Access Compliance Report

Public Rights-of-Way

(Curb Ramps)

Intersection ID: 10038355	Main Street: SOUTH_BV	Cross Street: N/A	Location: SW
ADA ID: B878CCCD0AD9	Ramp Type: Perp	Initial Pass/Fail: Fail	Overall Compliance: No
Severity Score: 12.5			
Codes/Mitigation Info/Possible Solution		Field Measurements/Component Compliance

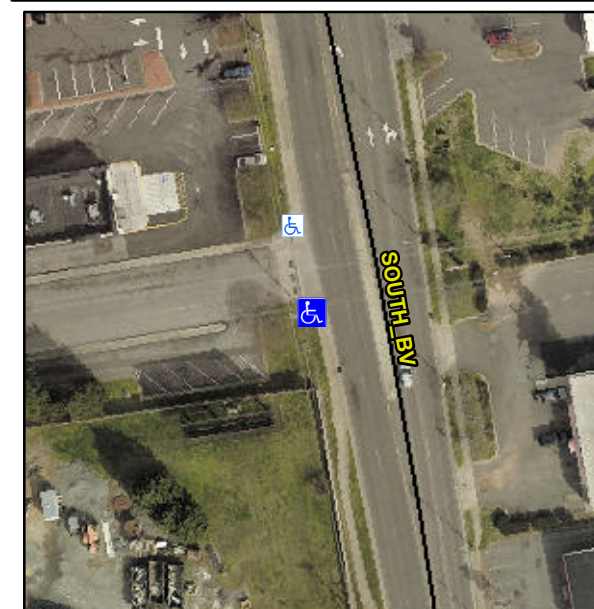
Not Found, R304.2.2

Compliance	Description	Data	Compliance	Description	Data
N/A	Ramp Length (in)	57.0	No	Ramp Slope (%)	8.4
Yes	Ramp Width (in)	48.0	Yes	Ramp XSlope (%)	1.6
N/A	Flare Type LT	N/A	N/A	Flare Type RT	N/A
N/A	Flare Slope LT (%)	N/A	N/A	Flare Slope RT (%)	N/A
N/A	Flare Traversable LT?	N/A	N/A	Flare Traversable RT?	N/A
N/A	Landing Length (in)	N/A	N/A	DWS Provided?	N/A
N/A	Landing Width (in)	N/A	N/A	DWS Contrast?	N/A
N/A	Landing Slope (%)	N/A	N/A	DWS Length (in)	N/A
N/A	Landing X Slope (%)	N/A	N/A	DWS Full Width?	N/A
N/A	Landing Curb? (Y/N)	N/A	N/A	DWS Offset (in)	N/A
N/A	Shared Landing?	N/A			
N/A	Gutter Ponding?	N/A	N/A	Gutter Slope (%)	N/A
N/A	Gutter Lip Ht (in)	N/A	N/A	Gutter X Slope (%)	N/A
N/A	Painted X Walk1?	No	N/A	Painted X Walk2?	N/A
	X Walk 1 Direction	To N		X Walk 2 Direction	N/A
N/A	X Walk 1 Width (in)	N/A	N/A	X Walk 2 Width (in)	N/A
	X Walk 1 Slope (%)	1.8		X Walk 2 Slope (%)	N/A
	X Walk 1 X Slope (%)	5.0		X Walk 2 X Slope (%)	N/A

Remove & Replace Entire Ramp.
